Newlin Gulch Major Drainageway Plan - Draft

Alternatives Analysis

June 2015

RE: Newlin Gulch MDP & FHAD
Alternatives Analysis Report
Agreement No. 12-09.02

DATE JUNE 2015
FIGURE NO. 5-1

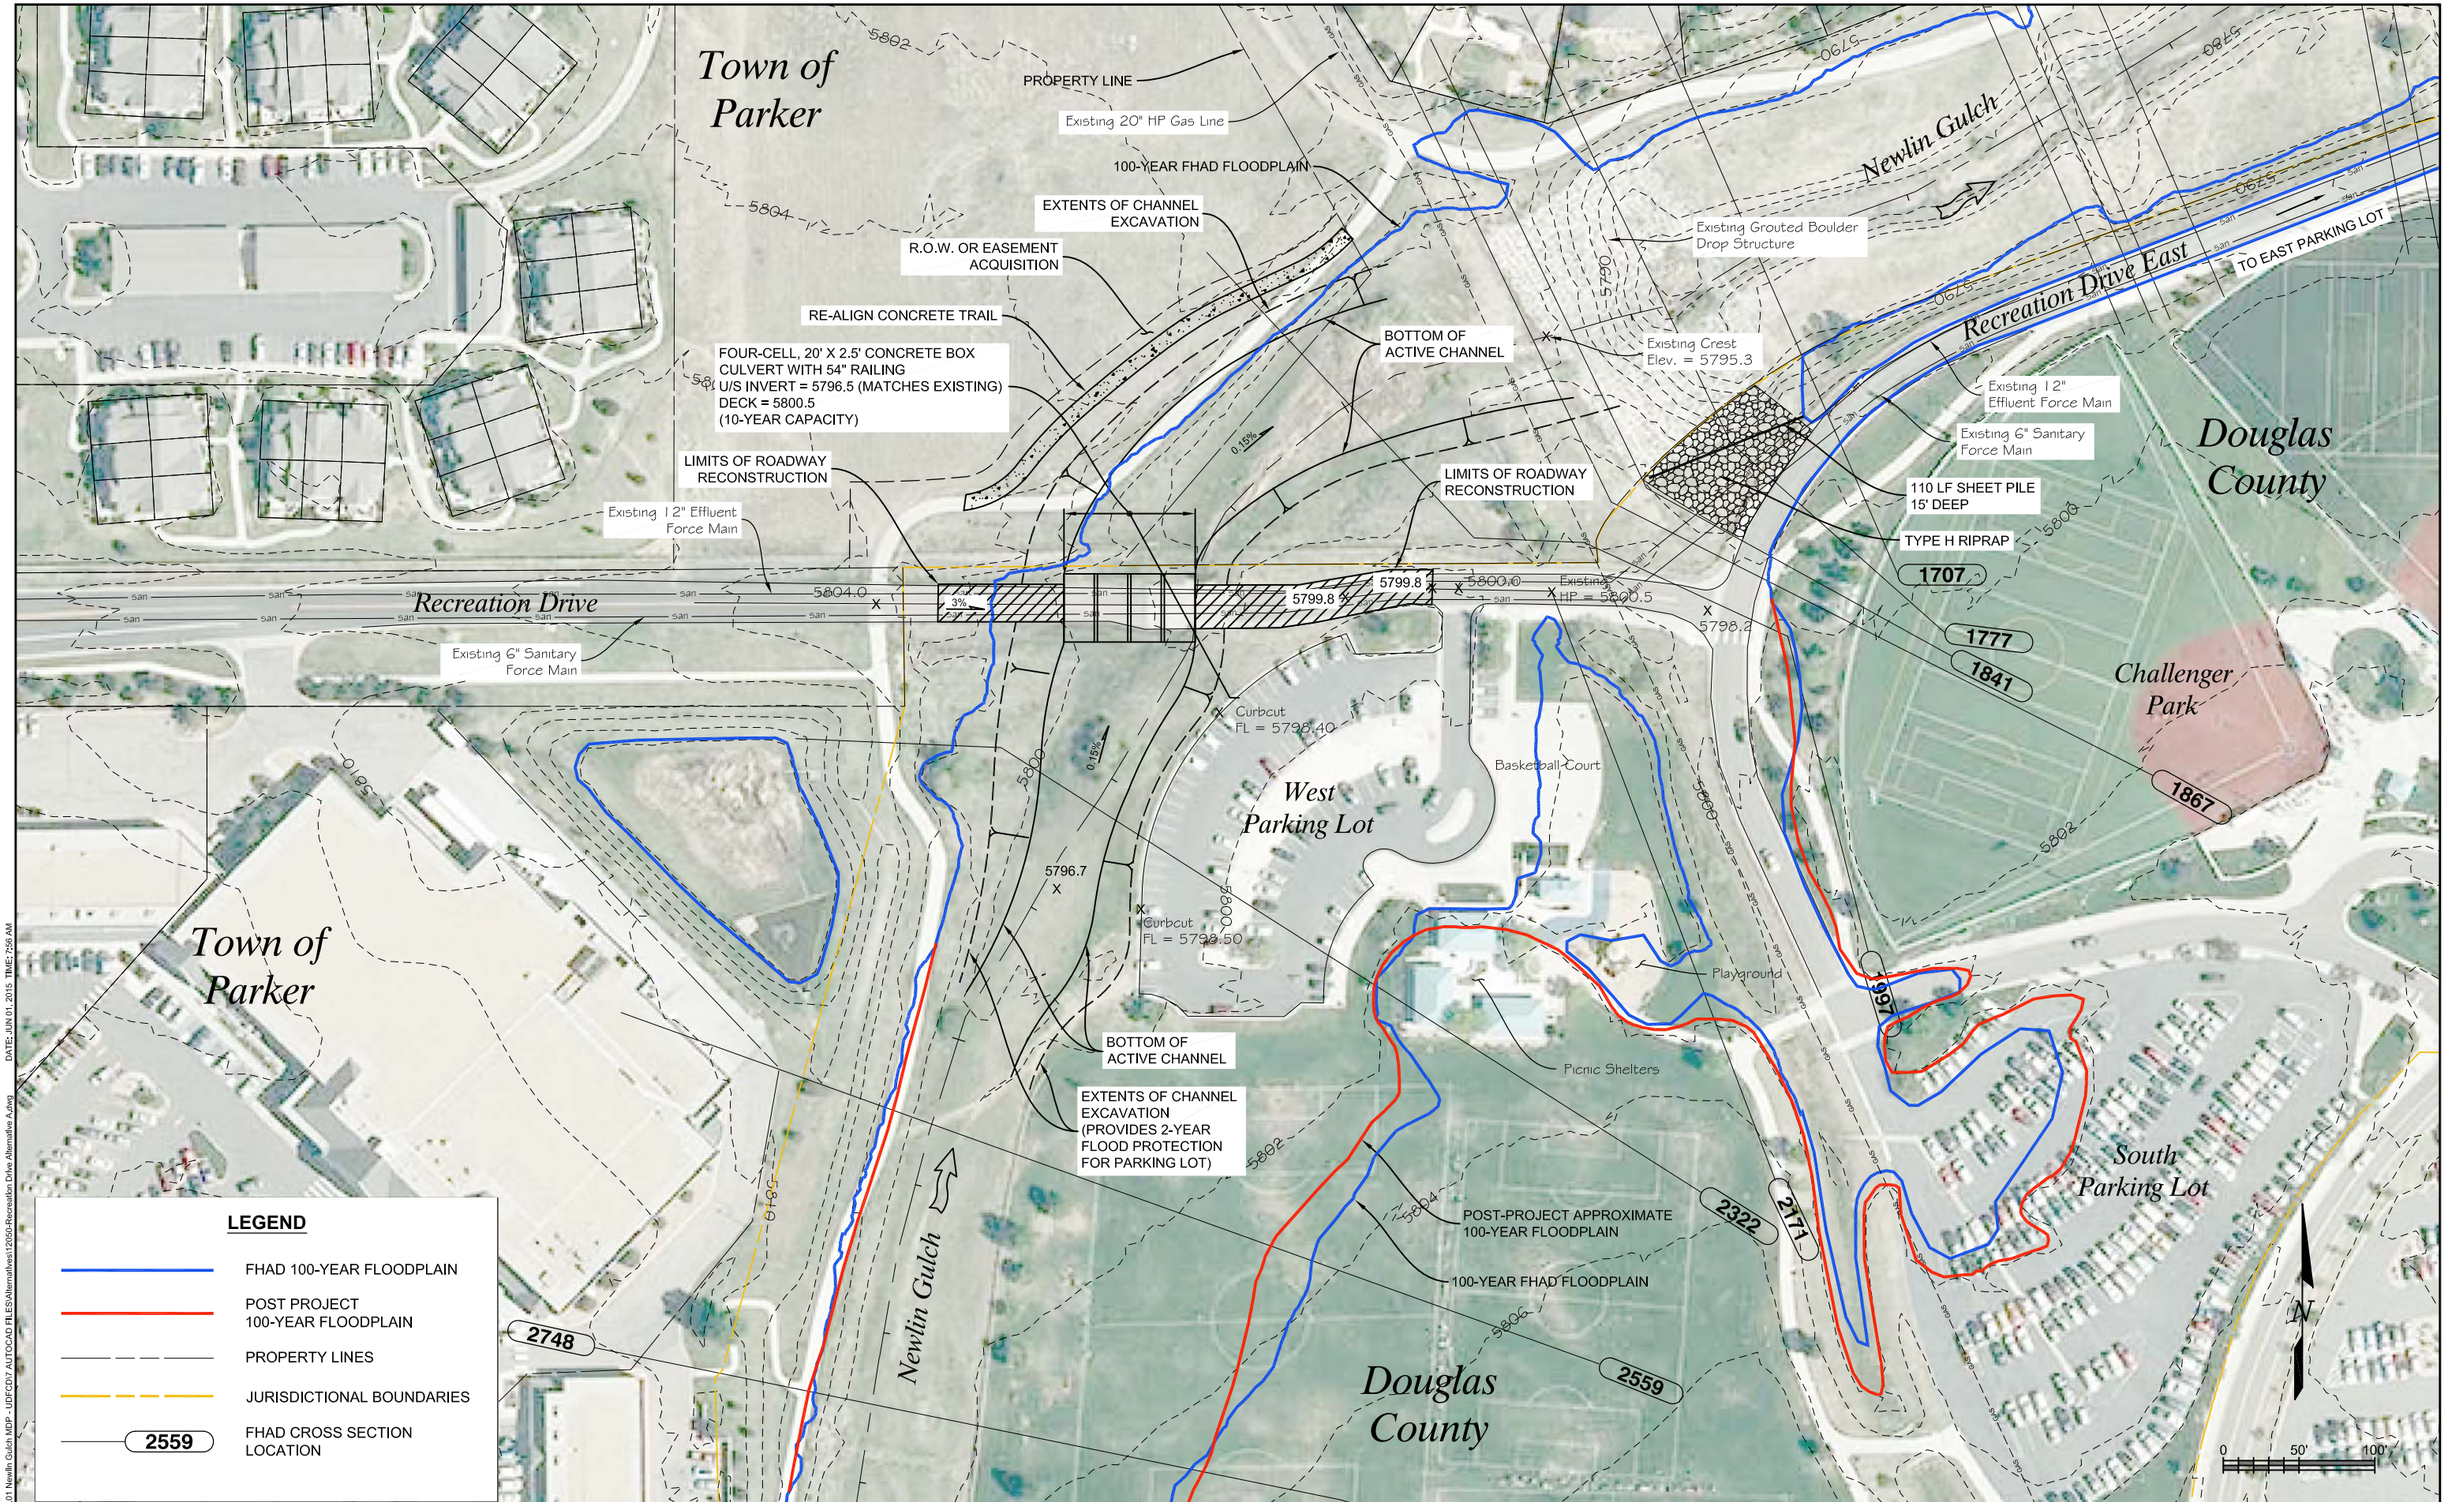
Figure 5-1 [Re: property impacts northeast of Recreation Drive crossing]
Would skewing the culverts help eliminate some of this property acquisition? Or would the culvert size no longer work?
Skewing the culverts may reduce the property impacts, though it will not eliminate them. The layout of the culverts will need to balance impacts on the property/trail, the parking lot, and the road profile and overtopping capacity. These factors will be considered more thoroughly during conceptual design, and a skew will be incorporated if appropriate.

Figure 5-1 Add sheetpile cutoff wall for 20" gas protection and possibly bank protection between the drop and Rec Dr. East
Sheet pile and riprap protection have been added to Alternative A.

DATE JUNE 2015
FIGURE NO. 5-2

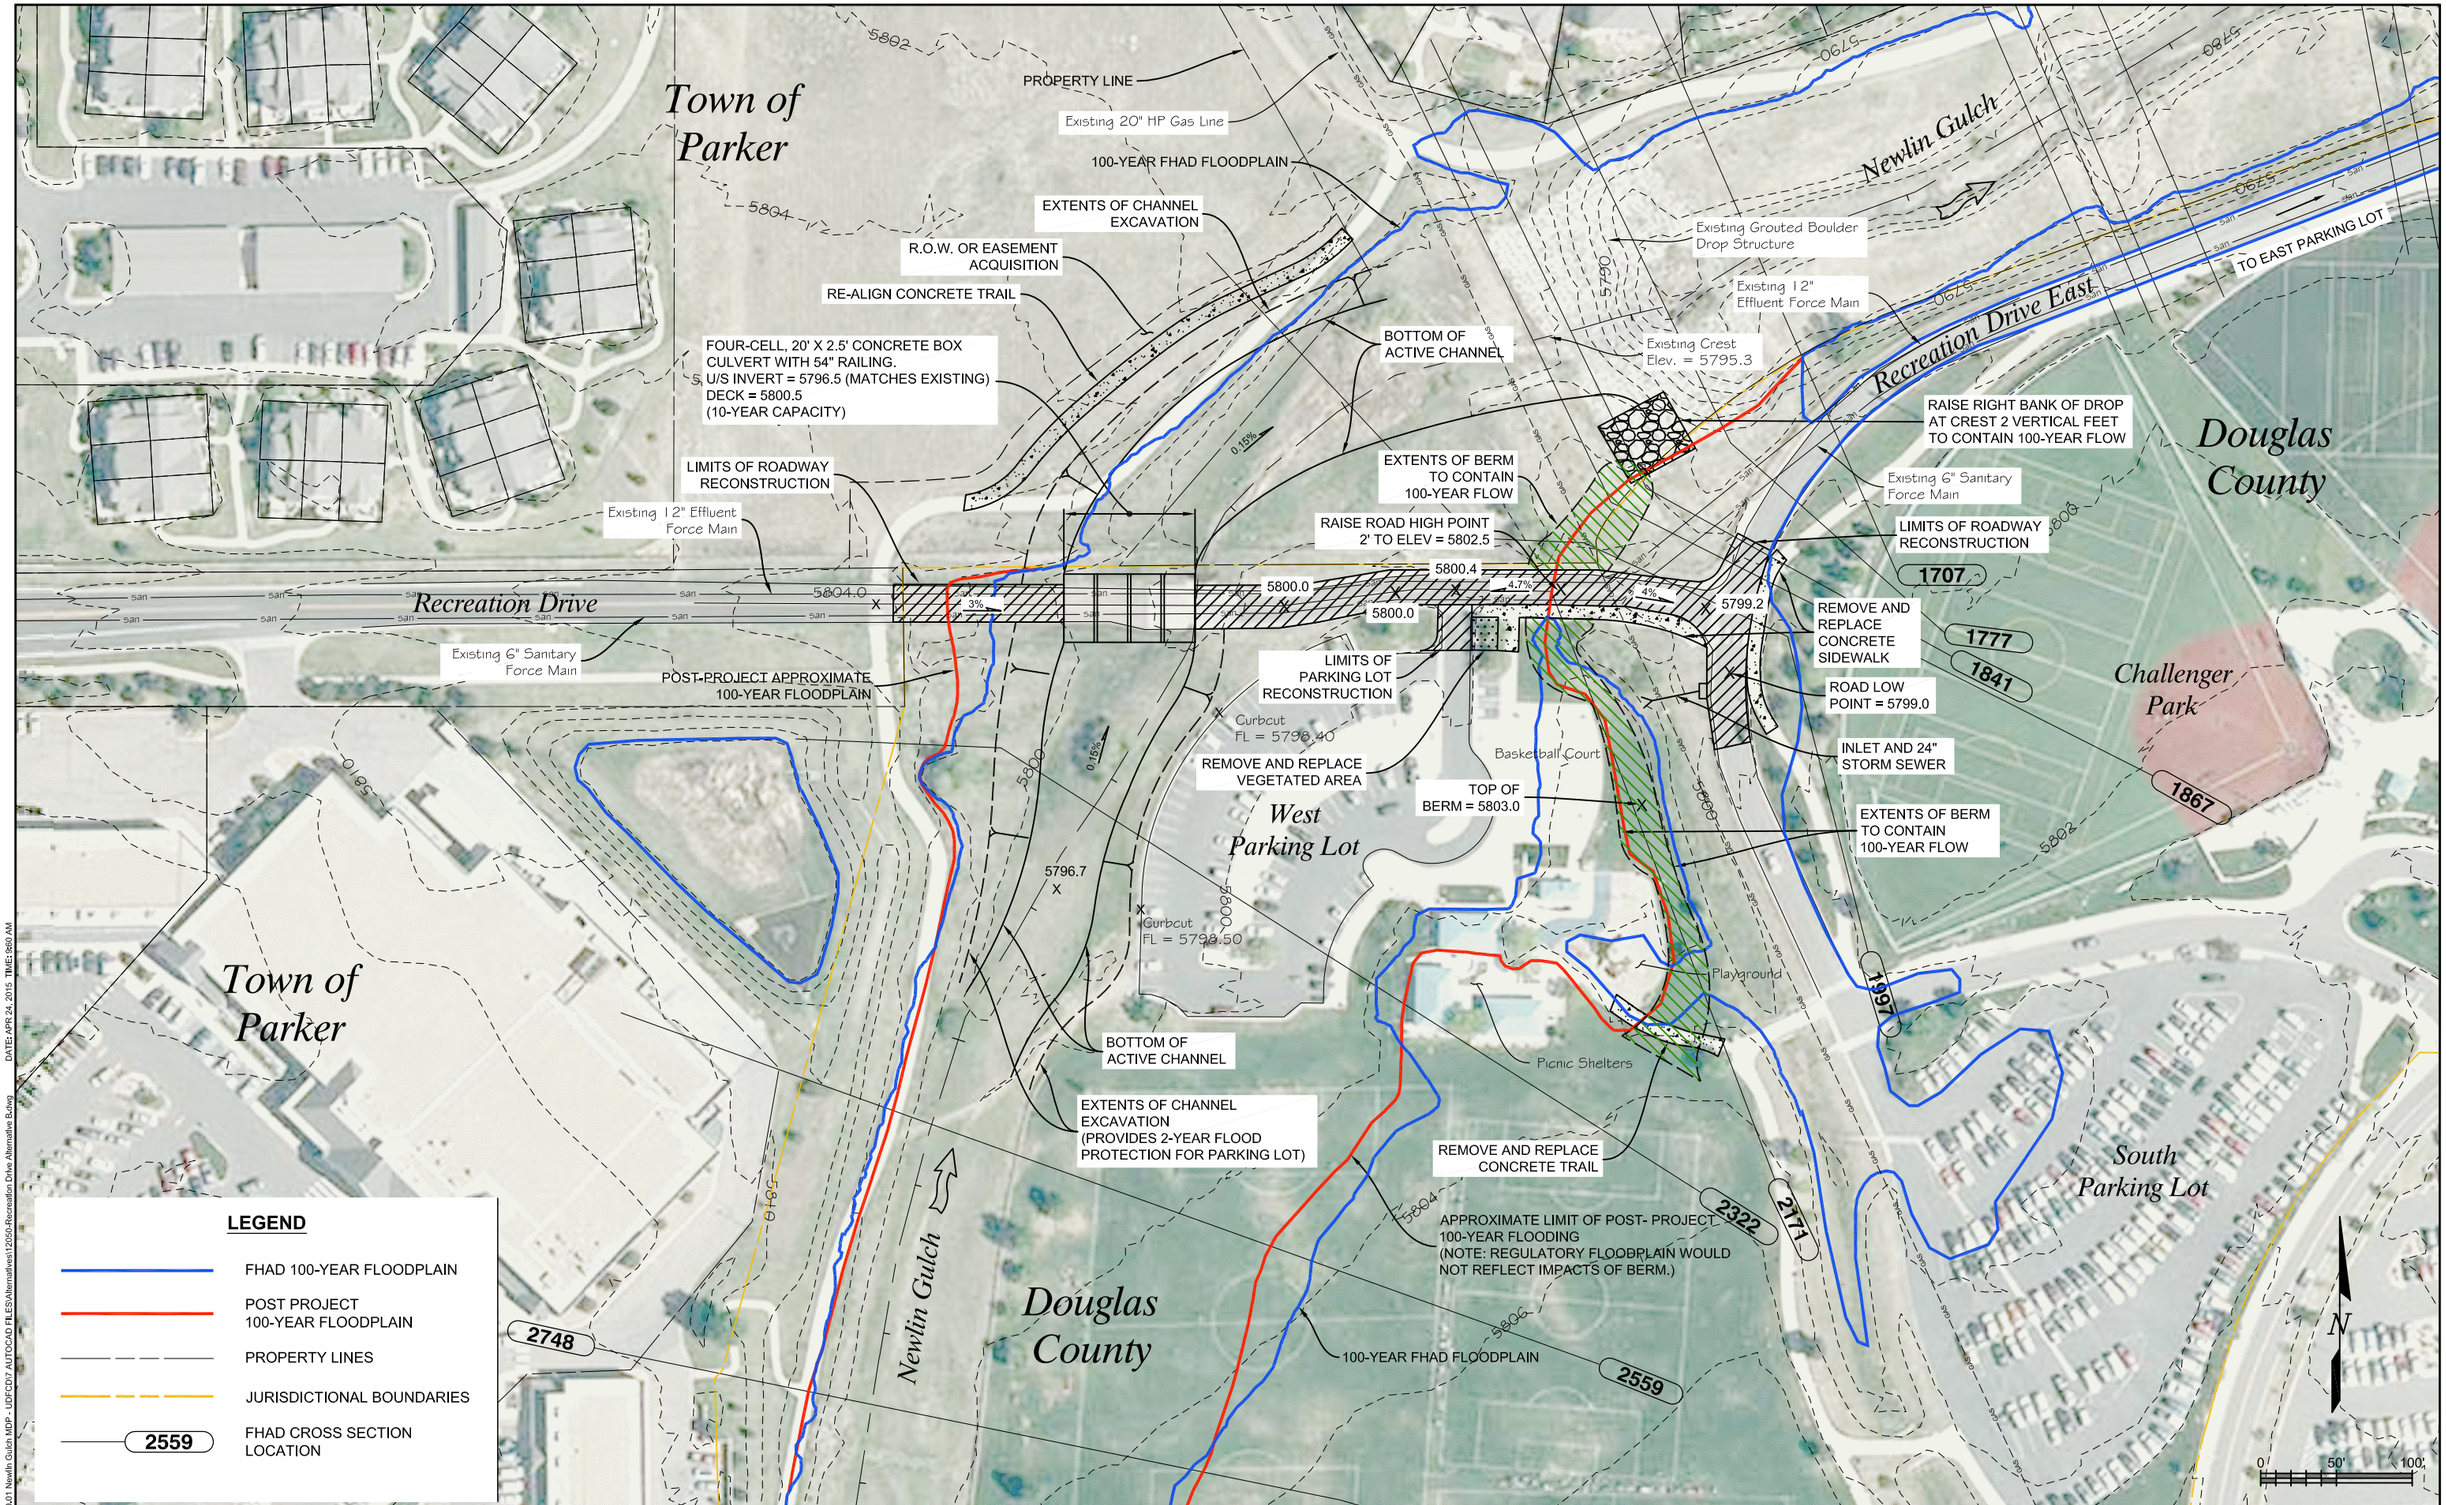
Section 5.5 [Re: Recreation Drive Alternative B "small one-foot high berm"]
I'm not sure what this would look like. It sounds like a levee - is there a way to grade the area that doesn't create a levee situation?
The berm is necessary to contain the 100-year flows. It is desired more from a general hydraulic perspective rather than a floodplain perspective; it is true that its impact on the mapped floodplain could not be recognized. This was clarified in the text and a note was added to Figure 5-2.
